To address the reviewer comments, we made two major revisions to the manuscript: 1) we reformulated the aim and changed the first research question, and 2) we used air temperature as the driver for ecosystem respiration. These revisions caused notable changes to the methods, results and discussion sections of the manuscript. We also removed the phytomass index from the gap-filling procedure and revised a minor calculation error affecting the fertilisation rate in 2019 (Table 1). As a result of the methodological changes, the reported values of the different components of the carbon balance changed a little, but this did not cause any changes to the conclusions. In addition to these two major revisions, we made several minor revisions according to the reviewer comments and suggestions and improved the language of the manuscript. The following response to reviewer comments explains the revisions that are visible in detail in the attached manuscript version with tracked changes.

Anonymous Referee #1:

Figure 6. Daily water use efficiency (WUE) during two growing seasons.

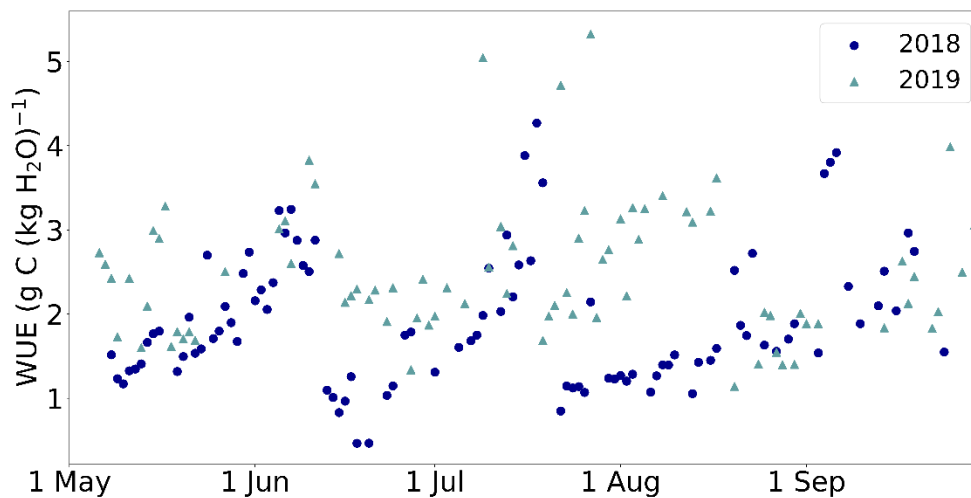
“Lines 361-363: With respect to the WUE analysis, I strongly recommend an additional approach to disentangle transpiration from total ET in order to make the statements on WUE more meaningful. I

understand that the ET components were not measured separately, but assuming that soil evaporation can be neglected in a grassland with complete canopy cover, the data set could for example be split into rainy and rainless days, and the rainless days be analysed separately. This would enable an alternative calculation of WUE from GPP and T if it is further assumed that, on rainless days, interception evaporation can be neglected, too.”

We agree. We found that most of the rainy days were already eliminated from the analysis as we used only the days when the latent heat flux was greater than 30 W m^{-2} . However, we further modified the filtering and removed all the rainy days. As a result of this change, 10 more data points were eliminated, and the results were affected very little. The relationship between WUE and LAI (Fig. 5) was not affected. Below updated Figure 6.
